## TECHNICAL MEMORANDUM

**To:** Bonnie Gestring, Earthworks  
**From:** Ann Maest, PhD; Buka Environmental  
**Date:** 15 October 2024  
**Re:** Stibnite Gold Project, Idaho: Objections to the Final Environmental Impact Statement (FEIS)  
Related to Geochemistry and Water Resource Issues

**Figure 1. Buckhorn Mine WTP influent water quality for nitrate+nitrite and ammonia concentrations from the start of mining (January 2008) to December 2023. Stibnite water quality standards are included as dashed lines (10 mg/L as N for nitrate+nitrite and 2.1 mg/L as N for ammonia).**

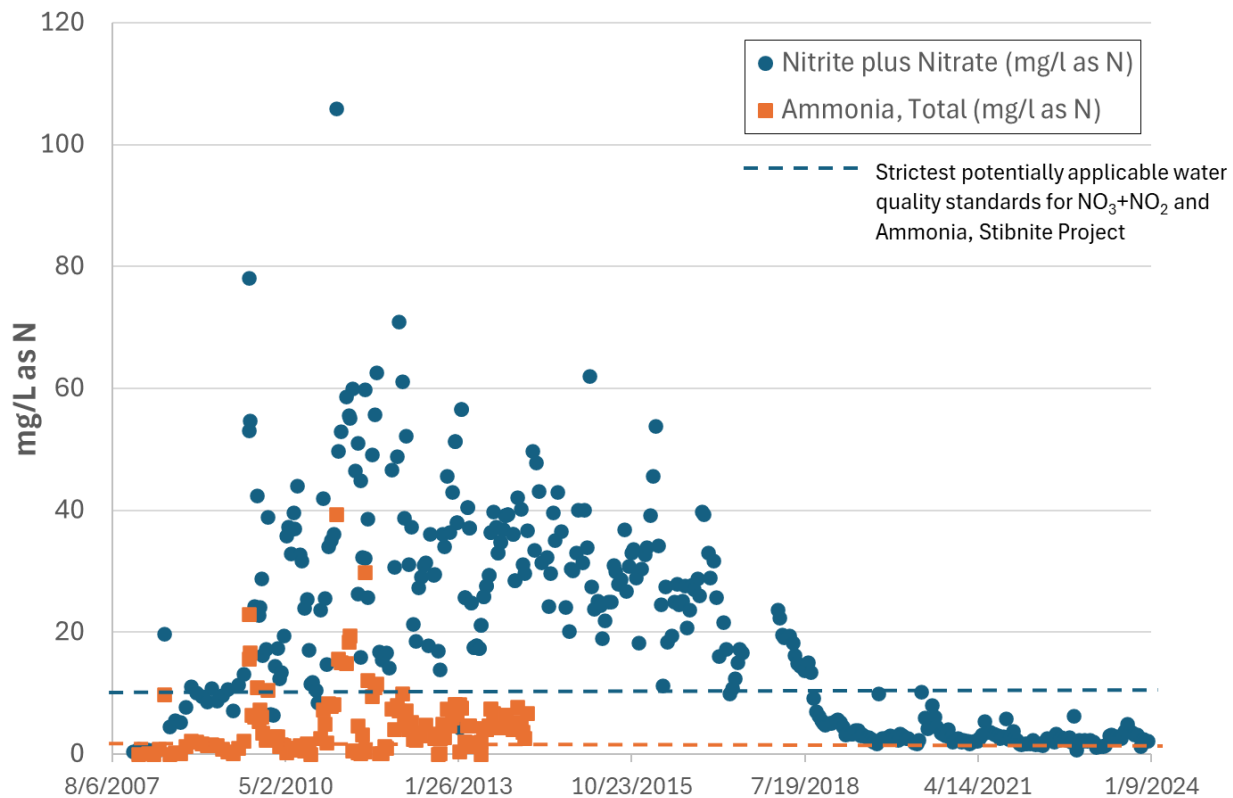
A more appropriate comparison is the Buckhorn Mine in northern Washington State. The Buckhorn Mine is a small, underground gold mine that closed in 2017 and if anything used lower amounts of blasting agents than what will be required for blasting open pits at the Stibnite Project. Buckhorn WTP influent ammonia concentrations from the start of mining (January 2008) to February 2014 averaged 4.90 mg/L as N, with a range of 0.01 to 39.3 mg/L as N (n = 156) (Appendix 1). Buckhorn WTP influent nitrate+nitrite concentrations (mg/L as N) averaged 20.4 mg/L and ranged from 0.43 to 106 mg/L (n=388). Nitrate+nitrite concentration results are available from December 2007 to December 2023 (in the most recent data delivery). Note that reporting of influent ammonia concentrations was discontinued in 2014, but monitoring for ammonia continued in the WTP effluent and groundwater and surface water monitoring locations. Figure 1 shows that during operations (2008-2017) WTP influent concentrations of nitrate+nitrite

and ammonia exceeded the strictest potentially applicable water quality standards/criteria for the Stibnite Project (10 for nitrate/nitrite and 2.1 for ammonia, mg/L as N). Influent nitrate+nitrite concentrations at the Buckhorn Mine were up to 10 times higher, and ammonia concentrations were up to 18 times higher, than the strictest potentially applicable Stibnite water quality values. As expected, influent nitrate/nitrite concentrations dropped after mining ceased, but during operations, concentrations of nitrate/nitrite and ammonia were quite elevated. Adding ammonia removal to the Stibnite WTP could require a new circuit – it may not be removed by the proposed approach. The Stibnite FEIS does not address the removal of ammonia in its WTP, and this lack of technical attention puts aquatic life at risk in Project receiving waters.

**Figure 2. Chloride concentrations at the Buckhorn Mine in water treatment plant influent and effluent from December 2007 through December 2024.**

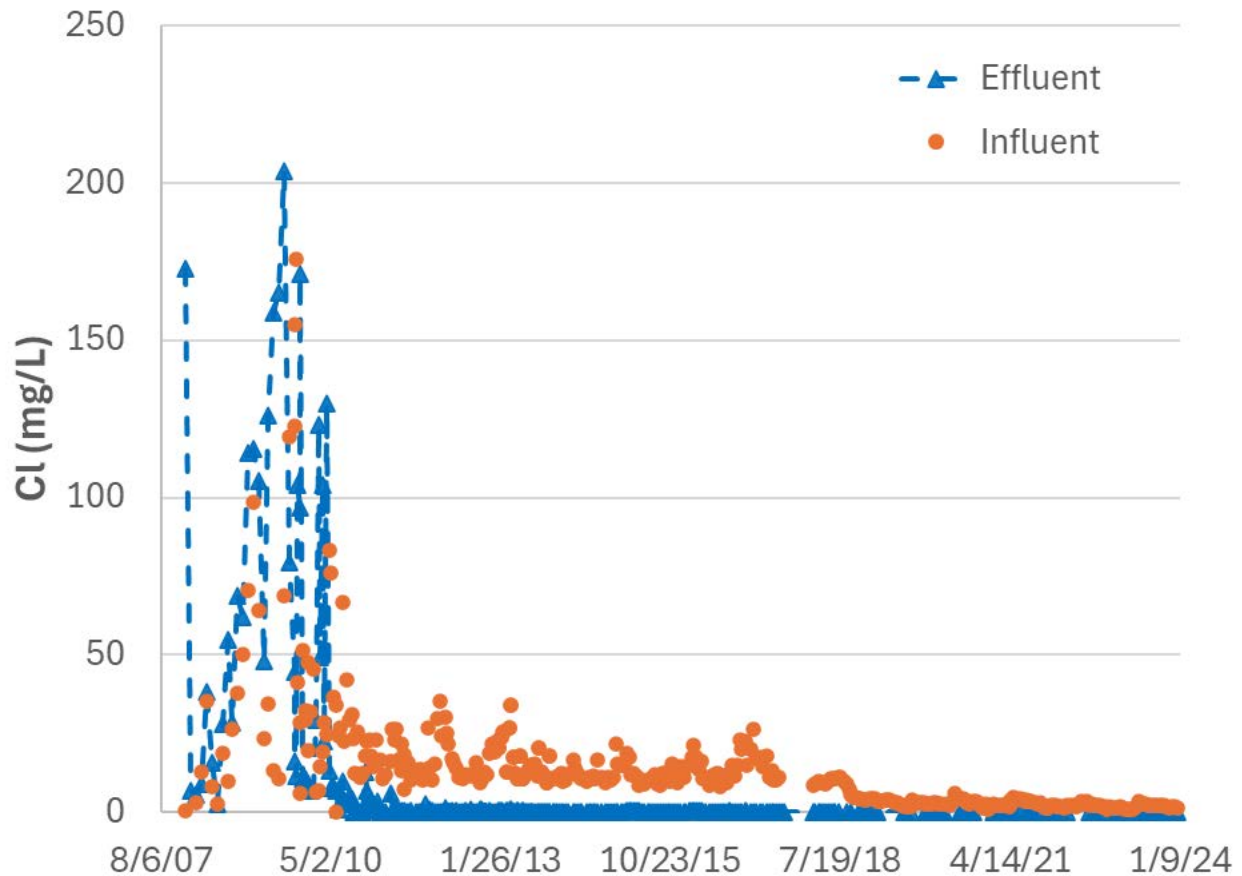
The Buckhorn Mine in northern Washington State started out with an ion exchange mine water treatment system and replaced it with reverse osmosis as the primary approach after seeing chloride concentrations rise precipitously in the effluent that was being discharged to area streams. Figure 1 shows chloride concentrations in WTP influent and effluent from December 2007 through December 2024 (and see Appendix 2). Note that effluent chloride concentrations were higher than influent concentrations until about mid-2010 as a result of the ion exchange system. After the WTP system was changed to a primary RO system, effluent chloride concentrations were low and consistently lower than influent values. Perpetua has not considered the addition of chloride to WTP effluent using the proposed water treatment approach.
